Field Report

The Park Danforth **Project No:** 13-059-00
Portland ME **Field Report No:** 15

Top of wall detail - Level 5

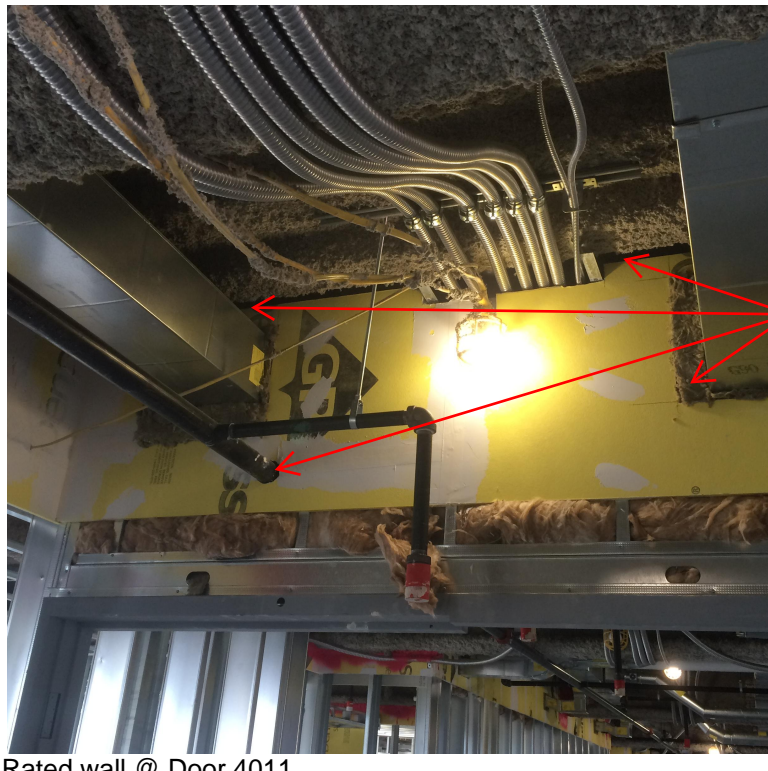
Maintain a 3/4" gap between drywall and the underside of structure/deck at all locations, typ. (Reference Photos P5 of 9)

Rated wall @ Door 4011

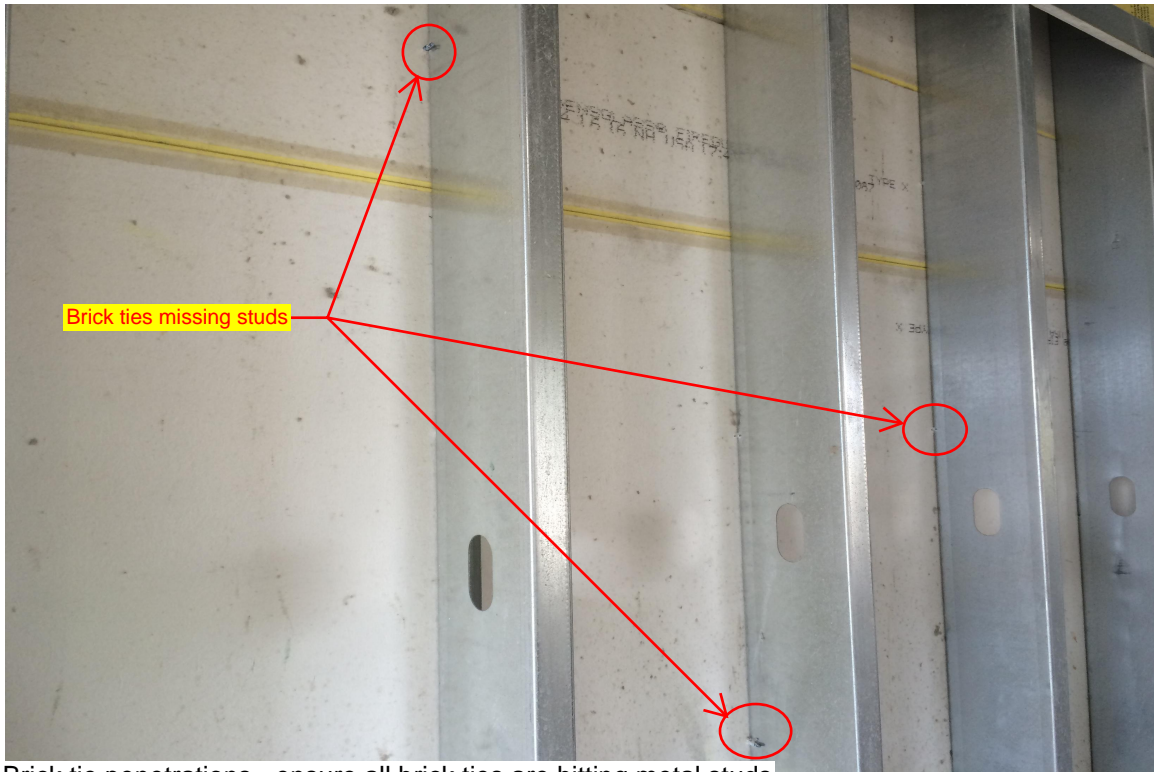
Item	Description	Status:
15.4	<u>Firestopping</u> There are a number of areas throughout the building where top of wall firestopping and/or partition penetrations have not been firestopped and subsequent work has been installed that will make firestopping difficult. All tops of rated wall and penetrations thru rated walls must be completely firestopped per their respective UL designs prior to start of ceiling construction. Reference Page P6 of 9 for examples. The horizontal rated drywall that was installed above door entrance 1111 needs to have it's joints and penetrations completely firestopped (no gaps). See Photos on page P9 of 9.	Correct Work

firestopping required at
top of wall and all
penetrations
